# McCLINTOCK STATION FILING NO. 2

## A VACATION AND REPLAT OF LOTS A & C, MCCLINTOCK STATION

JOB NO. 25251.00  
MAY 4, 2023  
SHEET 1 OF 4  
PCD FILE NO. \_\_\_\_\_

AS-PLATTED

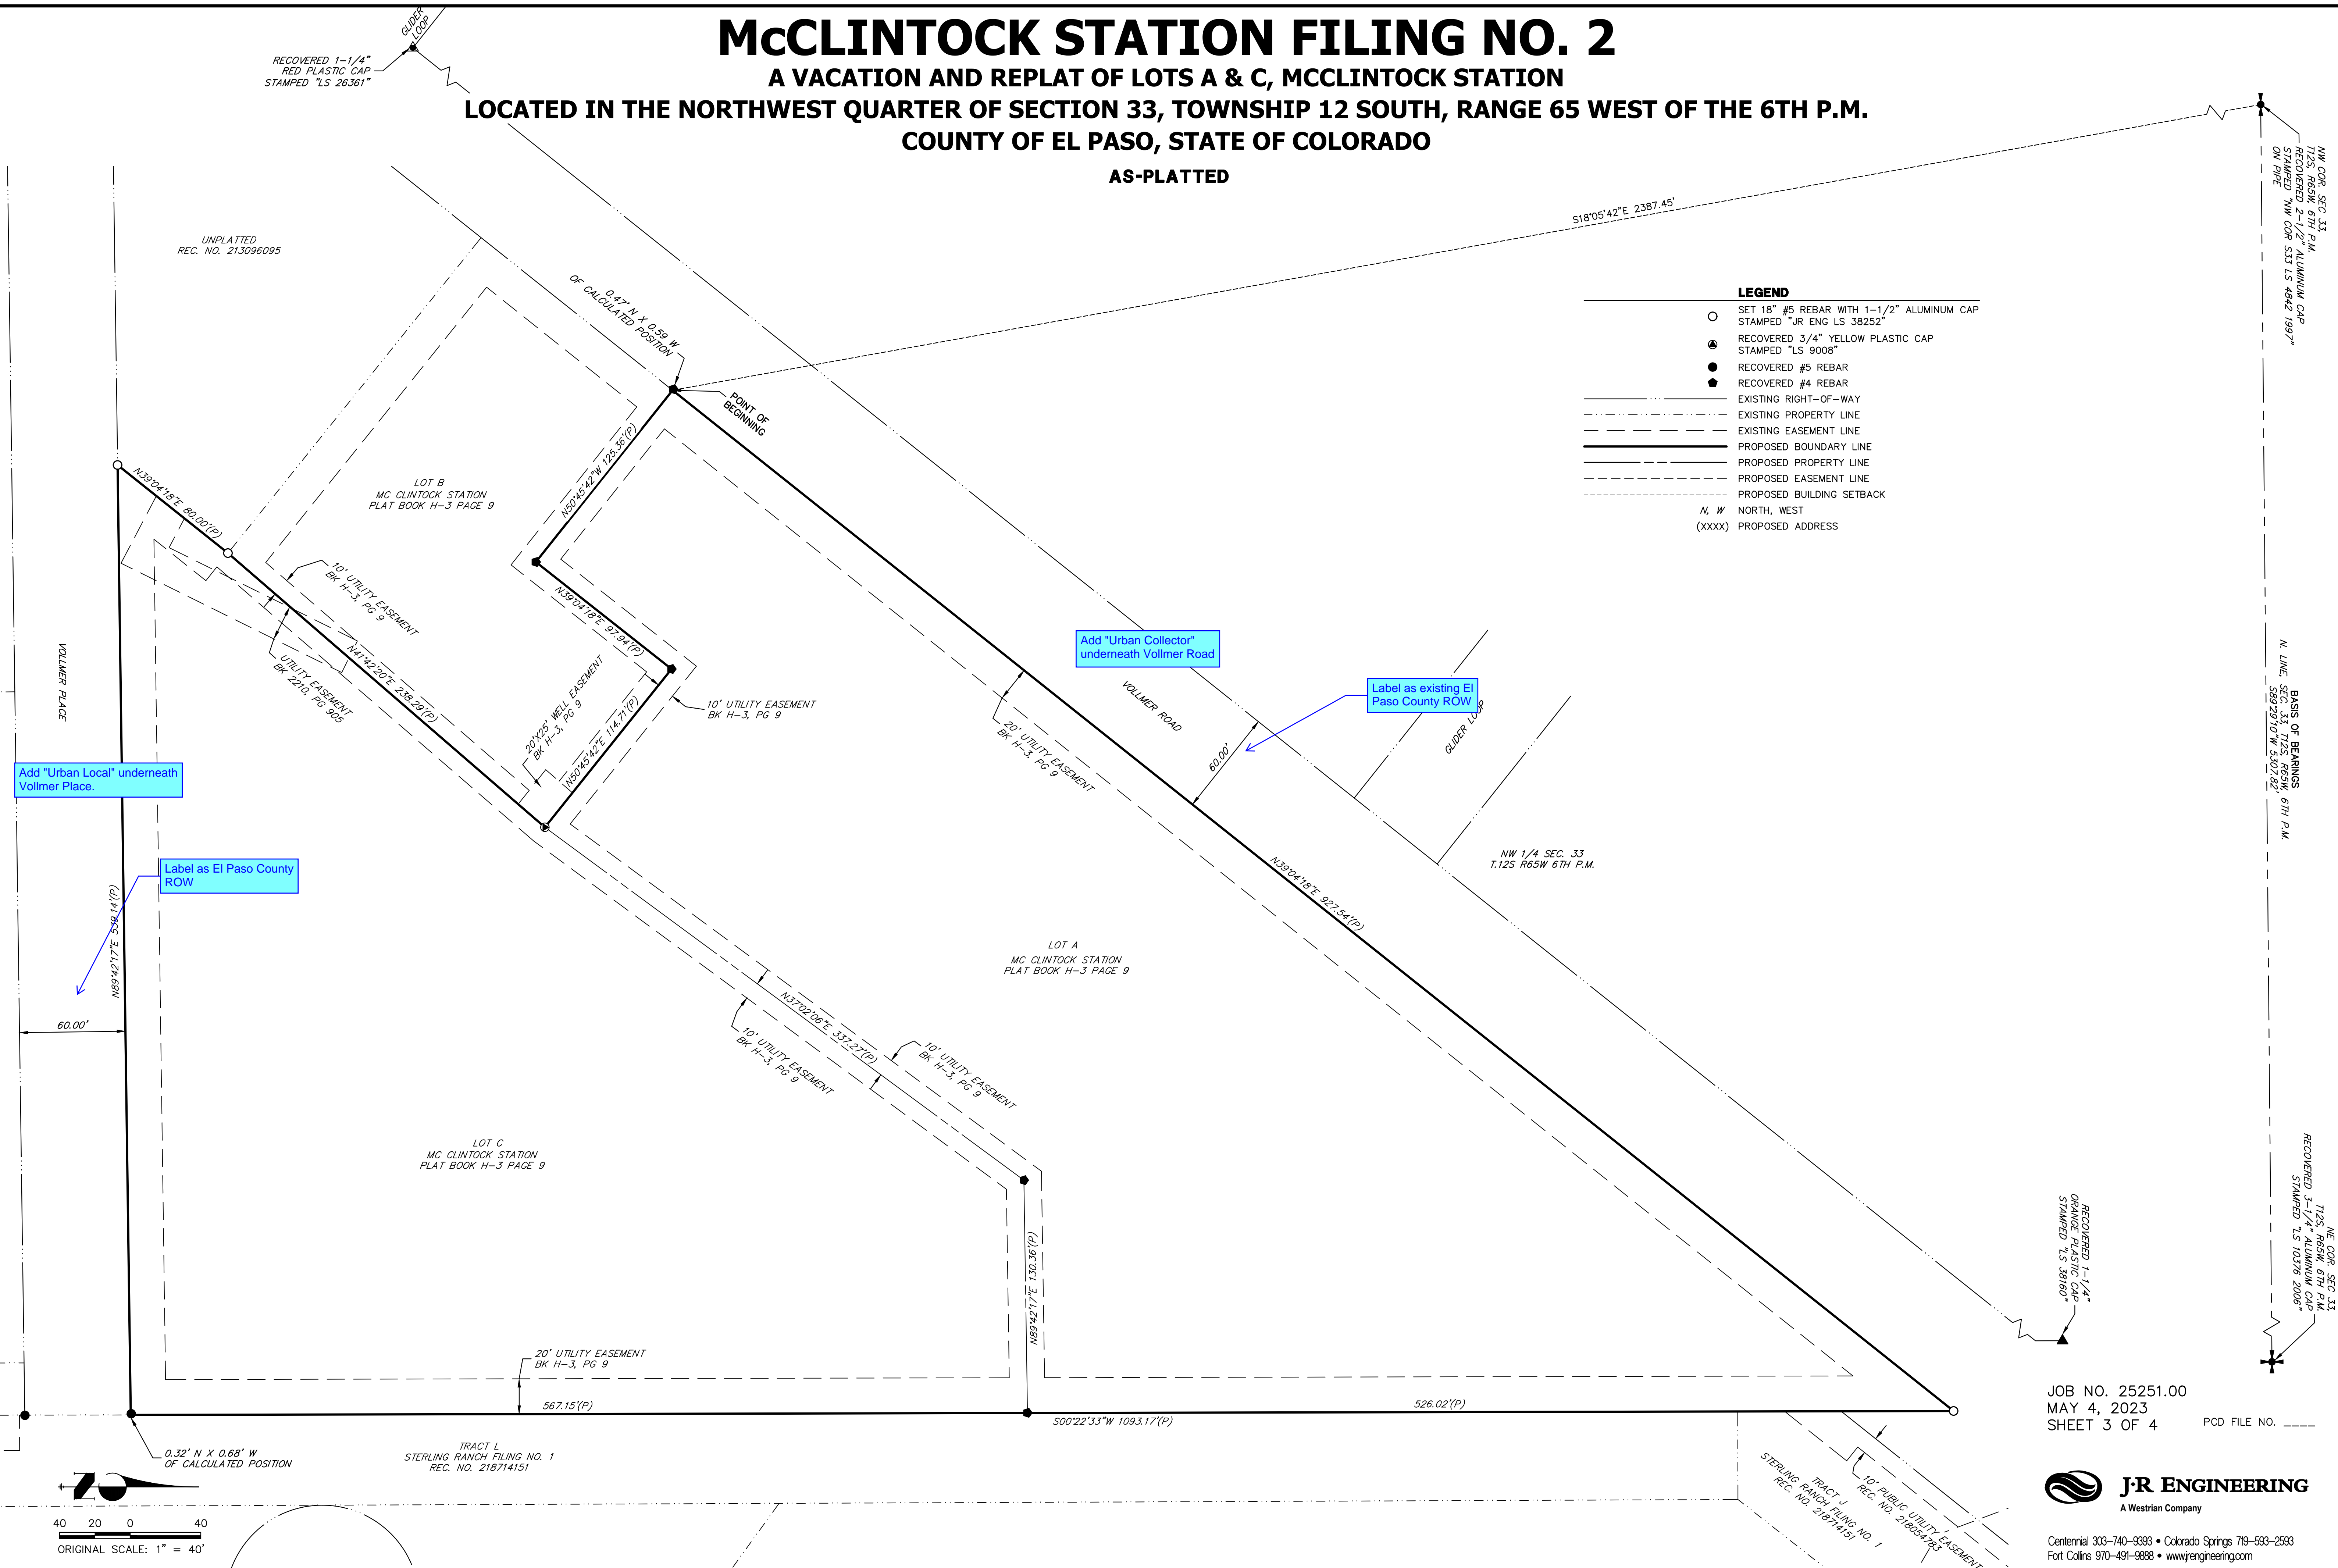
Add "Urban Local" underneath Vollmer Place.

Add "Urban Collector" underneath Vollmer Road

Label as existing El Paso County ROW

Label as El Paso County ROW

AS-REPLATTED

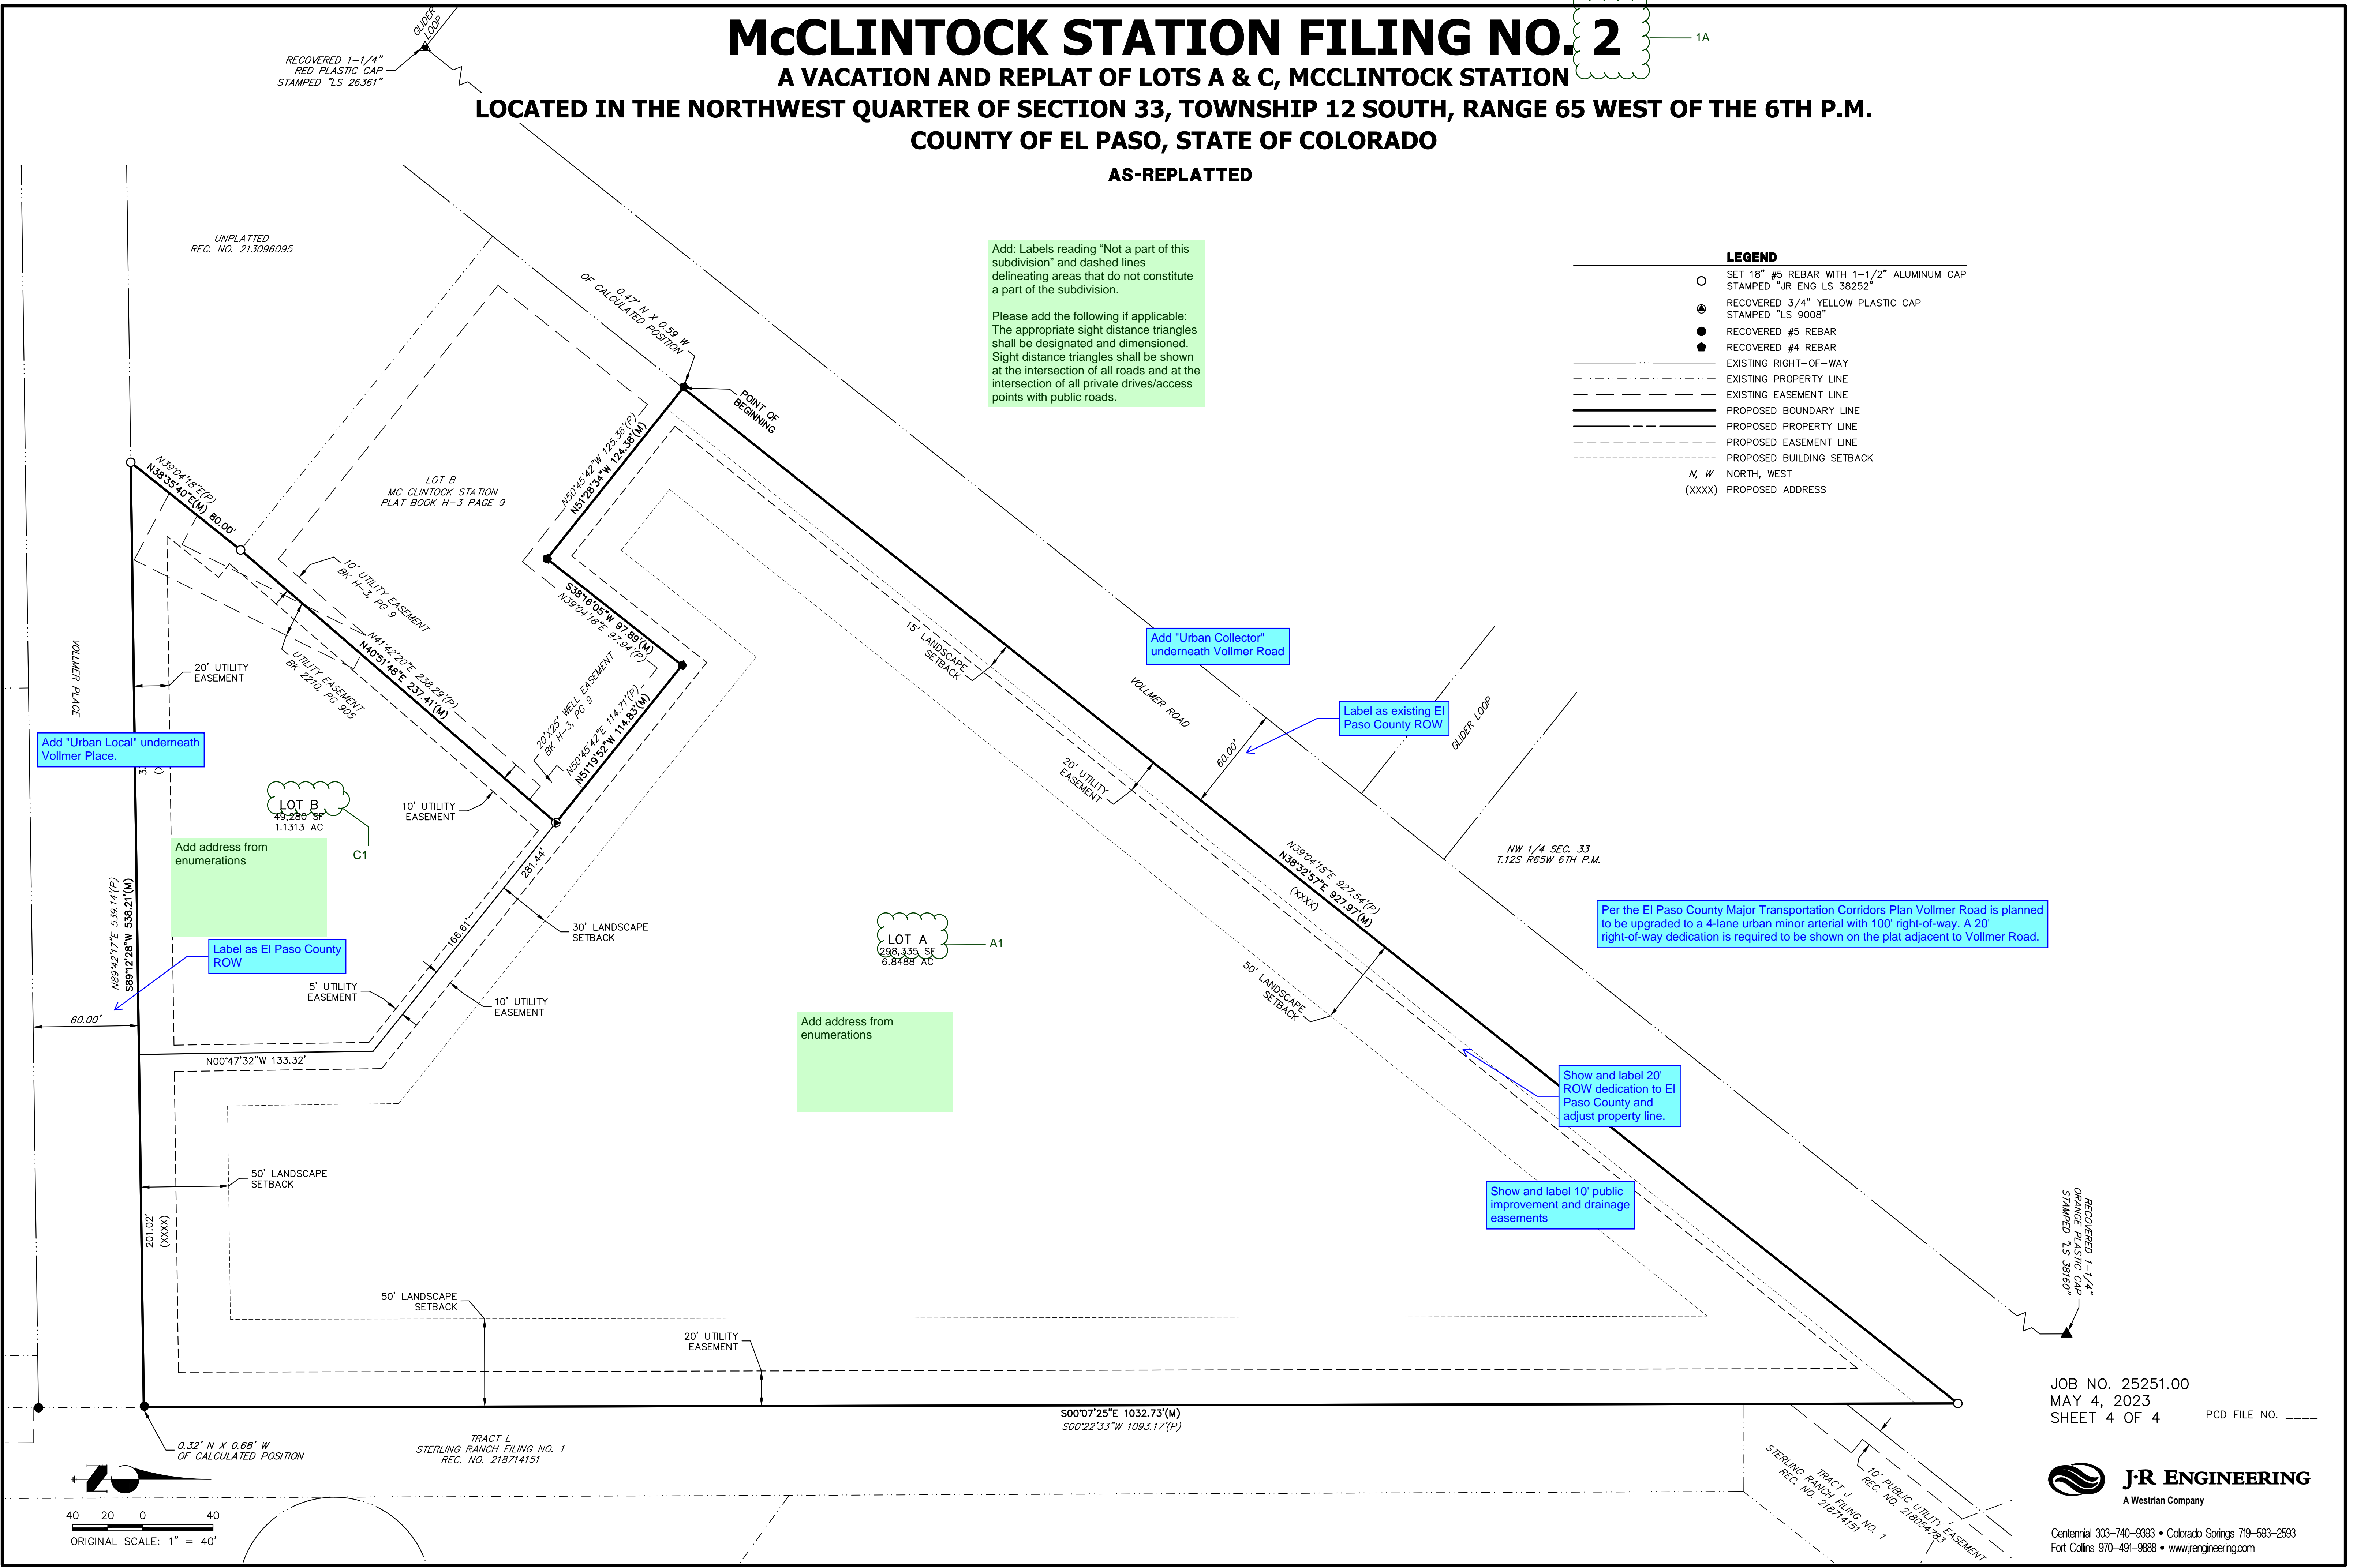
Add: Labels reading "Not a part of this subdivision" and dashed lines delineating areas that do not constitute a part of the subdivision.

Please add the following if applicable: The appropriate sight distance triangles shall be designated and dimensioned. Sight distance triangles shall be shown at the intersection of all roads and at the intersection of all private drives/access points with public roads.

Add "Urban Local" underneath Vollmer Place.

Add address from enumerations

Label as El Paso County ROW

Add address from enumerations

Add "Urban Collector" underneath Vollmer Road

Label as existing El Paso County ROW

Per the El Paso County Major Transportation Corridors Plan Vollmer Road is planned to be upgraded to a 4-lane urban minor arterial with 100' right-of-way. A 20' right-of-way dedication is required to be shown on the plat adjacent to Vollmer Road.

Show and label 20' ROW dedication to El Paso County and adjust property line.

Show and label 10' public improvement and drainage easements
